**DC-10****SERVICE BULLETIN SUMMARY****NOTE:** This summary is for information only and is not FAA approved for modification of aircraft.**SUBJECT:** Install Warning Placard For  
Portable Oxygen Generators.

BULLETIN 35-12  
DC-10 SC 1849

OXYGEN - Passenger - Install Oxygen Generator Heat Shield Pictorial Warning Placards.

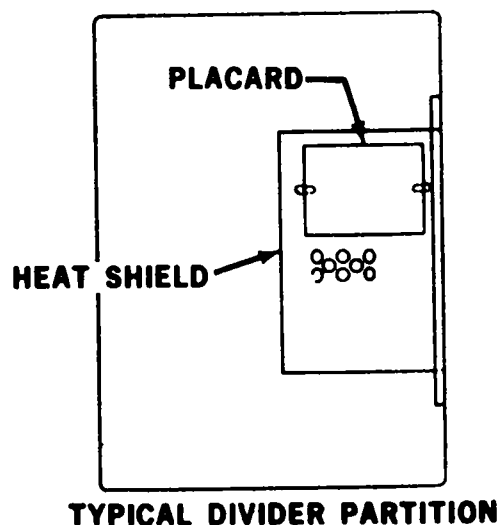
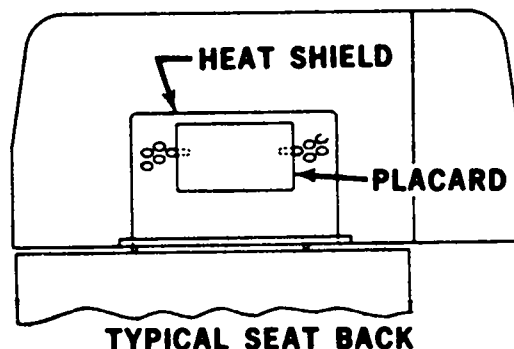
One operator has reported one incident of sudden cabin decompression activating the oxygen generating units. These canisters become extremely hot when operating and can cause burns if touched. Installing a pictorial placard clearly depicting the generated heat will reduce the possibility of accidental burns.

This modification installs a pictorial warning placard on the oxygen generator heat shield, located in the back of the passenger seats and cabin partitions.

- A. Gain access to modification area by manually opening oxygen compartment door. (See Chapter 35-22-00.)
- B. Form ABM7228-517 placard to approximate contour of oxygen generator heat shield.
- C. Install placard on heat shield by inserting tabs through existing holes in shield and bend tabs back as shown on Figure 1.
- D. Close oxygen compartment door. (See Chapter 35-22-00.)
